STAFF REPORT: 2/8/2023 MEETING

APPLICATION NUMBER: #23-8212

ADDRESS: 450 AMSTERDAM

SCOPE OF WORK: DEMOLISH ADDITION AND REHABILITATE BUILDING

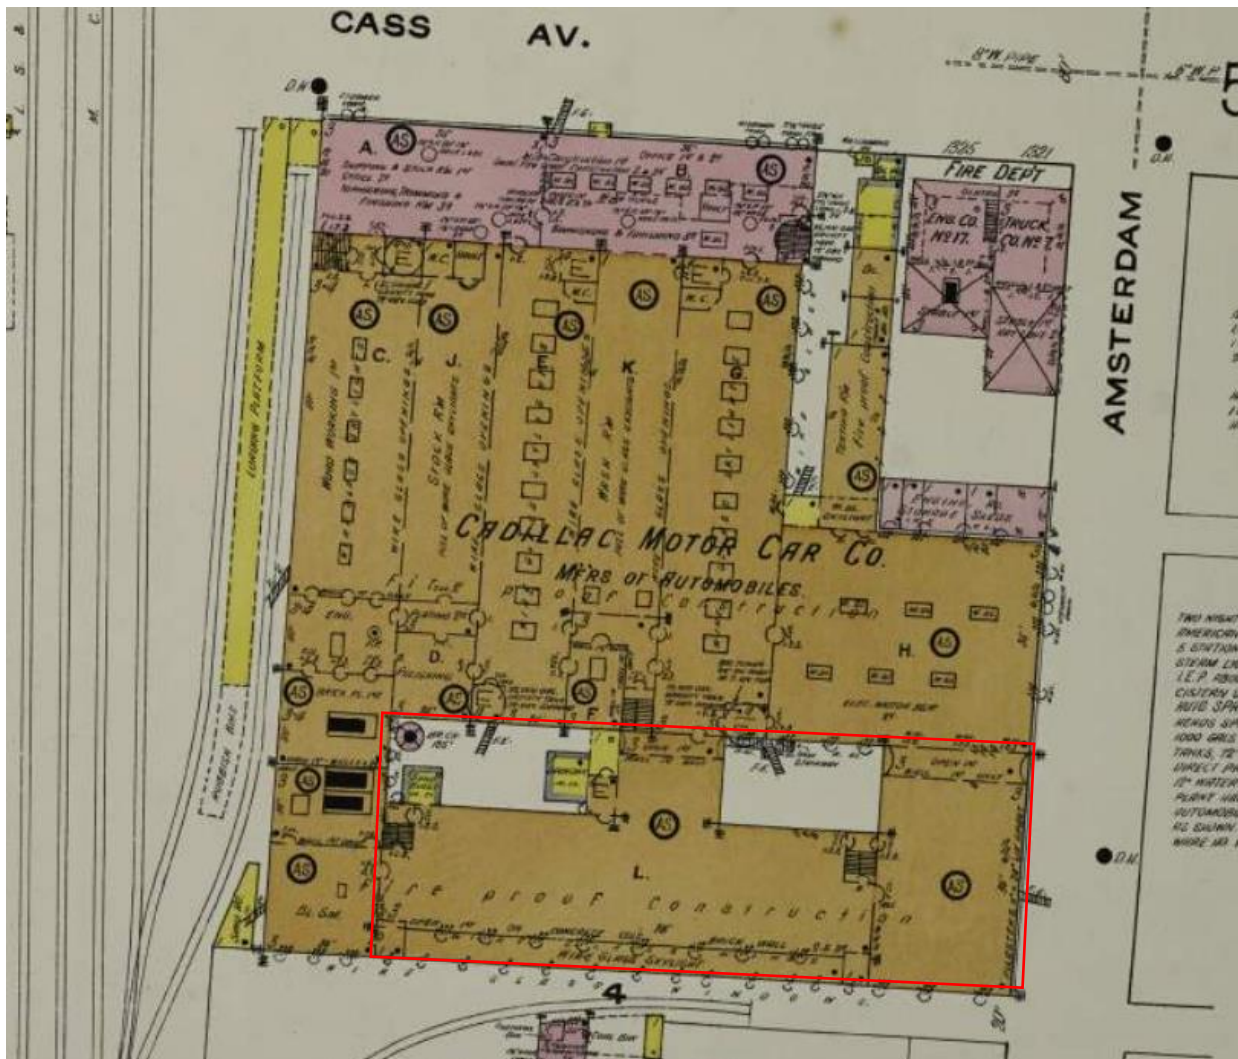
- Per submission, replace all existing historic steel windows, masonry infill with vinyl slider windows, and glassblock windows with new aluminum fenestration. **Please see the submitted demolition drawings to note that most window openings at the side and rear elevations will be enlarged to allow for the replacement of deteriorated lintels and/or the installation of new windows which are slightly larger or wider than the current/historic openings.** Only the window openings at the north/primary elevation will retain their original dimensions.

- The size of the window openings shall be consistent/regular at the building elevations that are visible from the public right-of-way (front and side elevations)
- HDC staff shall be afforded the opportunity to review and approve the final detail drawings and brick sample for the proposed rear/north elevation reconstruction. Should staff determine that the work item does not meet the SOI Standards, the item will be submitted to the Commission for review at a future meeting
- The applicant shall provide staff with the outstanding product cut sheets for the new single hinged doors which are proposed for installation at the side elevations

Sanborn Fire insurance Map, 1910 showing original footprint with existing portion outlined in red

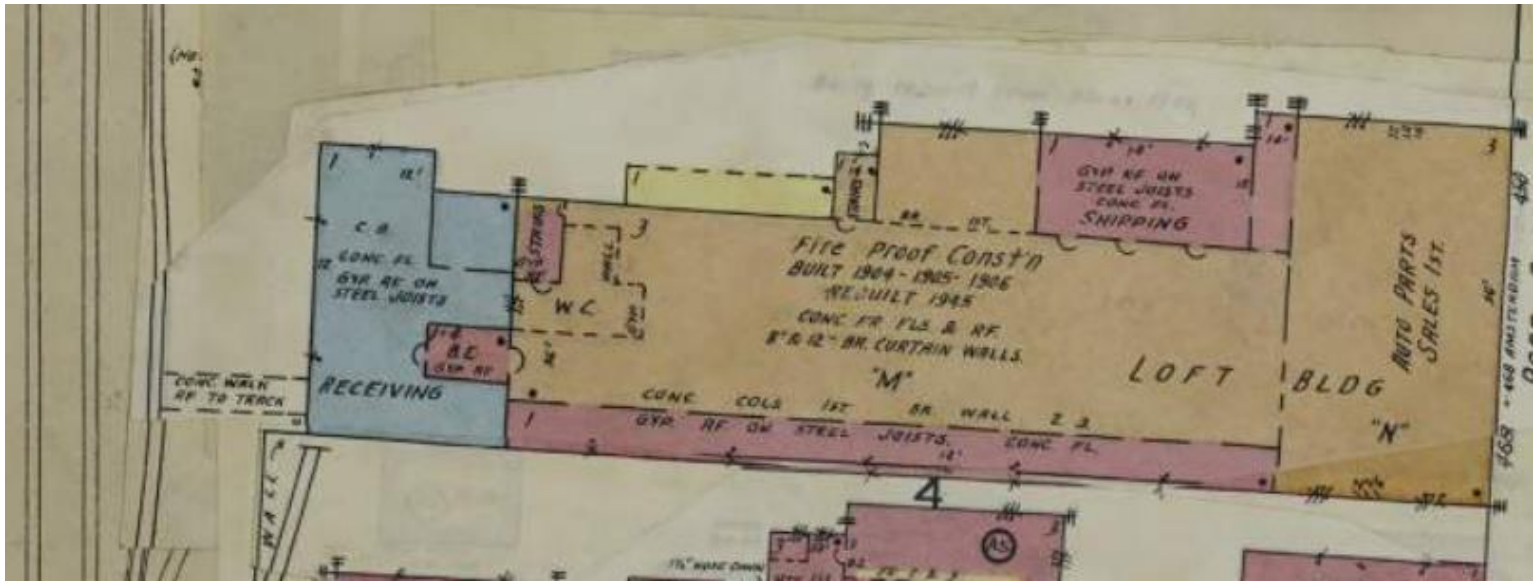
- As noted above, the building was originally erected in 1905 to serve as the Cadillac Motor Car Company Assembly Plant. See the below 1910 Sanborn Fire Insurance map which depicts the footprint of the original complex. In 1945, per the below Sanborn Fire Insurance map, much of the original plant had been demolished and the east elevation one-story addition and loading dock and the north elevation, one-story addition had been added. It also appears that the first story at the west elevation had been modified during the 1945 rehabilitation.
